## **REMARKS**

### **I. Status of the Application**

### **II. The Drawings**

FIG. 1

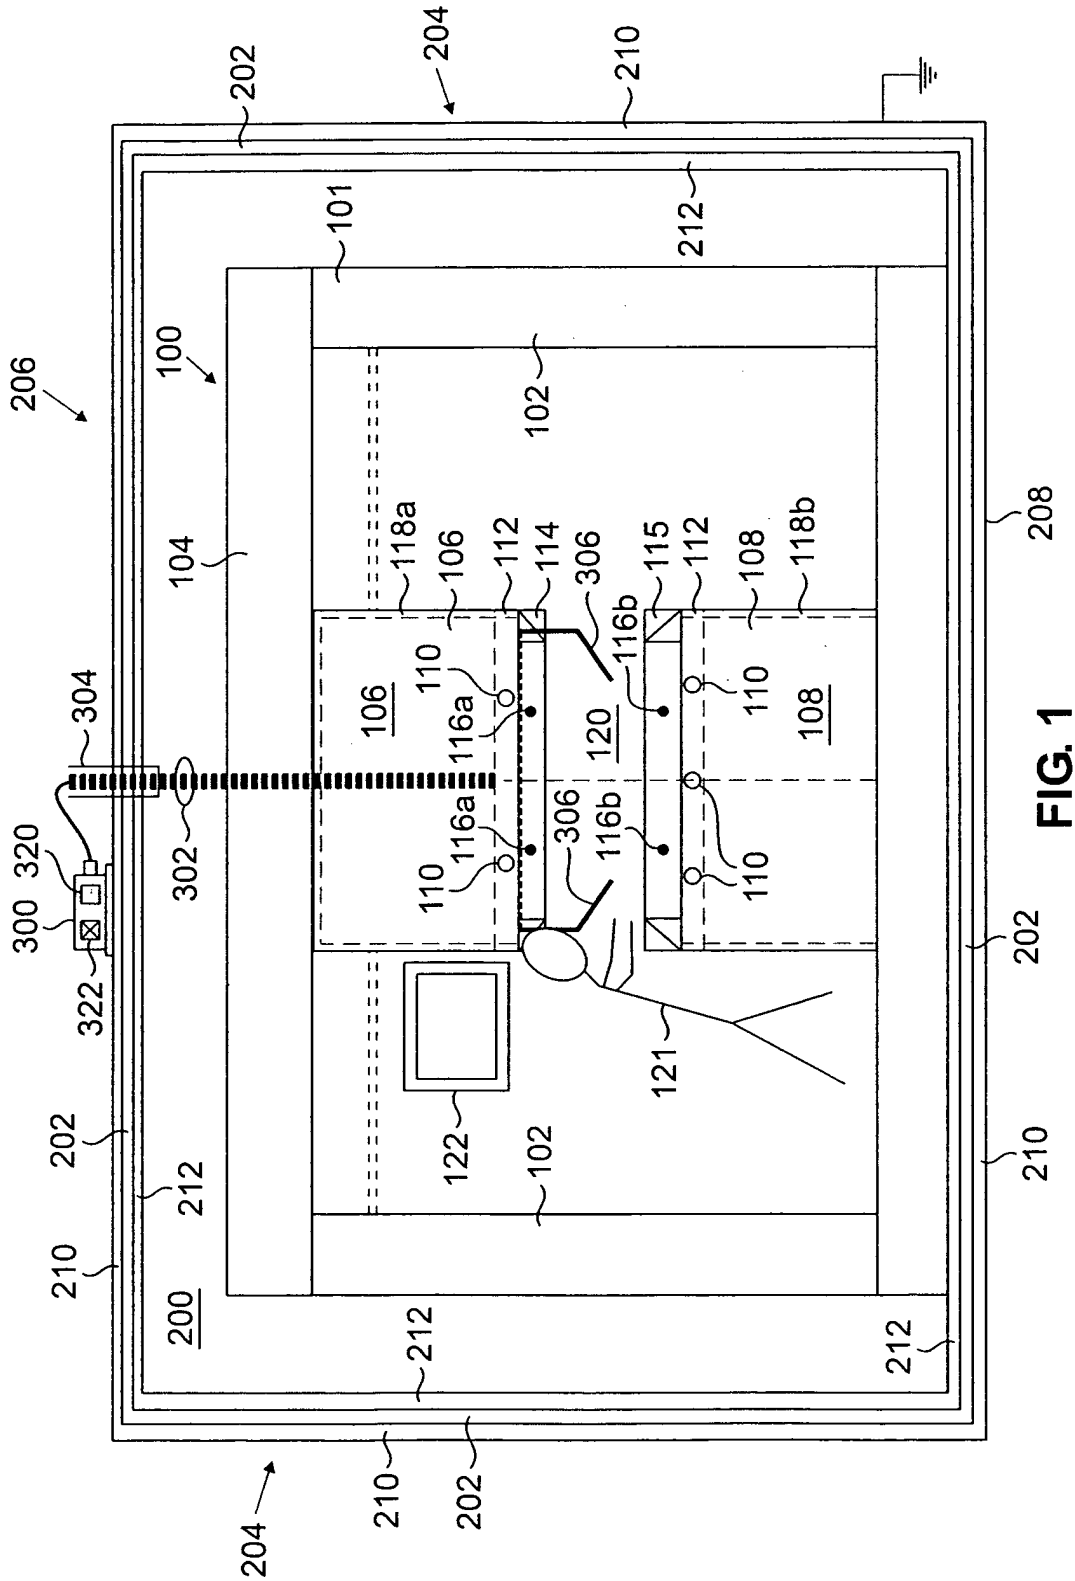
The drawings have been objected to as allegedly failing to comply with 37 CFR § 1.84(p)(5), because they allegedly do not contain reference numbers 101, 106a, 114, 116, 118a, 118b, 124, 320, and 322.

In Fig. 1, numeral 101 is inserted in Fig. 1, numeral 118 is changed to 118a or 118b, and a bulb 320 and a fan 322 are added, as described on page 8, lines 5-9. In Fig. 2, numeral 116b is changed to 116a and numeral 118 is changed to 118a. In Fig. 3, numerals 106a and 118a are inserted. The paragraphs starting on page 5, line 4 and on page 5, line 22 are amended to delete references to numeral 116. The Examiner is thanked for pointing out these omissions.

Replacement drawings for the original drawings are enclosed, along with a marked up set of drawings showing the changed and added numerals, as well as the bulb 320 and the fan 322, highlighted in yellow. No new matter has been added.

FIG. 2

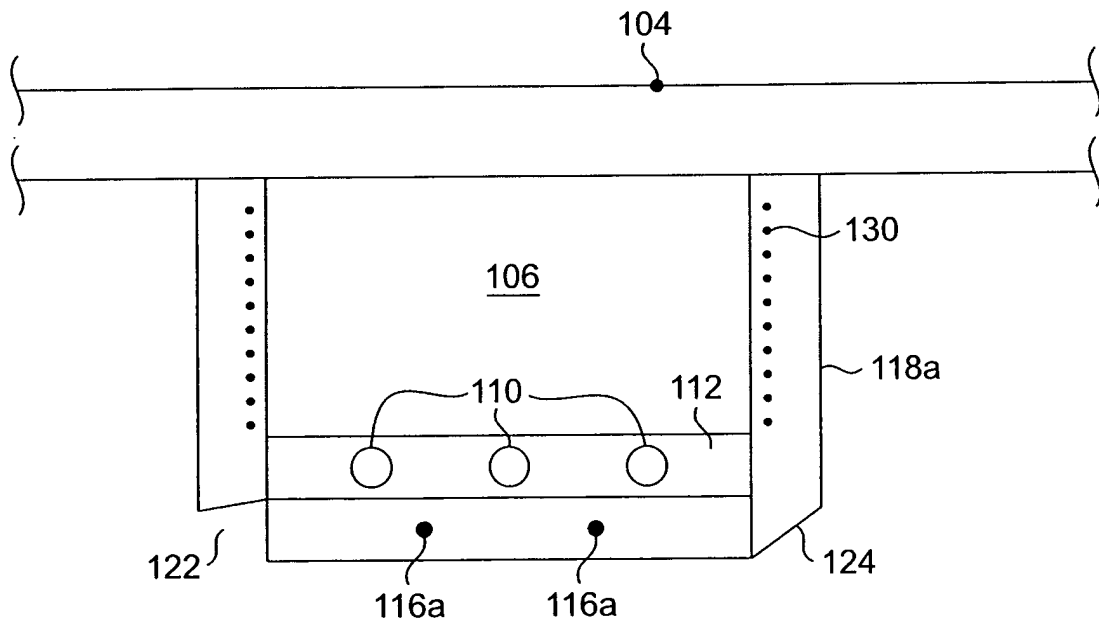
Reference numerals 114 and 124 are shown in original Fig. 1 and in Fig. 2, respectively. The paragraph starting on page 6, line 14 is amended to delete reference to Fig. 1, since item 124 is only shown in Fig. 2.

FIG. 3

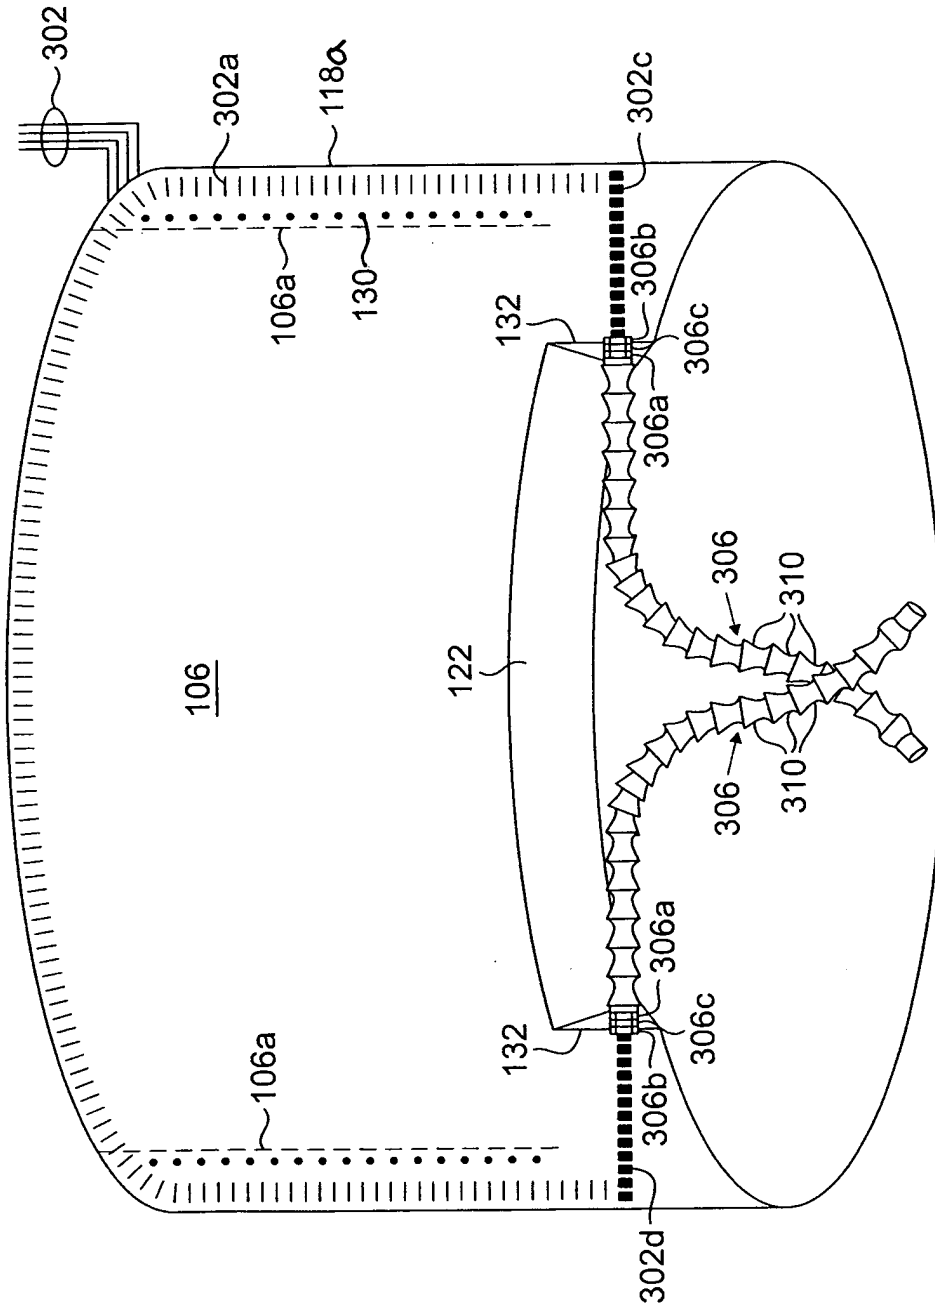
In addition, numeral 130, which appears in Fig. 2, is added to Fig. 3.
